Access Compliance Report

Public Rights-of-Way

(Curb Ramps)

Intersection ID: 10019463	Main Street: ALEXANDER MARTIN AV	Cross Street: N/A	Location: N
ADA ID: AFC47541B9BD	Ramp Type: PerpDiag	Initial Pass/Fail: Fail	Overall Compliance: No
		Severity Score: 35

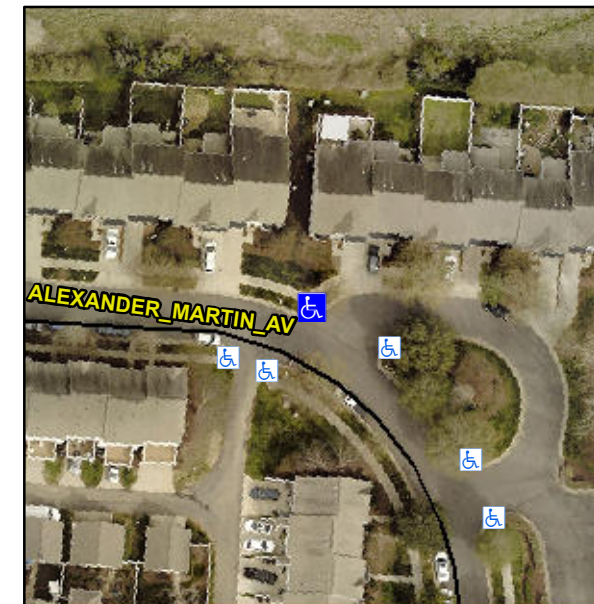
Not Found, R304.5.1

Compliance	Description	Data	Compliance	Description	Data
N/A	Ramp Length (in)	76.0	Yes	Ramp Slope (%)	6.7
No	Ramp Width (in)	28.0	Yes	Ramp XSlope (%)	1.8
N/A	Flare Type LT	N/A	N/A	Flare Type RT	N/A
N/A	Flare Slope LT (%)	N/A	N/A	Flare Slope RT (%)	N/A
N/A	Flare Traversable LT?	N/A	N/A	Flare Traversable RT?	N/A
N/A	Landing Length (in)	N/A	N/A	DWS Provided?	N/A
N/A	Landing Width (in)	N/A	N/A	DWS Contrast?	N/A
N/A	Landing Slope (%)	N/A	N/A	DWS Length (in)	N/A
N/A	Landing X Slope (%)	N/A	N/A	DWS Full Width?	N/A
N/A	Landing Curb? (Y/N)	N/A	N/A	DWS Offset (in)	N/A
N/A	Shared Landing?	N/A			
N/A	Gutter Ponding?	N/A	N/A	Gutter Slope (%)	N/A
N/A	Gutter Lip Ht (in)	N/A	N/A	Gutter X Slope (%)	N/A
N/A	Painted X Walk1?	No	N/A	Painted X Walk2?	No
	X Walk 1 Direction	To SW		X Walk 2 Direction	To SE
N/A	X Walk 1 Width (in)	N/A	N/A	X Walk 2 Width (in)	N/A
	X Walk 1 Slope (%)	3.2		X Walk 2 Slope (%)	1.7
	X Walk 1 X Slope (%)	1.9		X Walk 2 X Slope (%)	0.2

Remove & Replace Curb Ramp With Two New Directional Ramps or Equivalent.
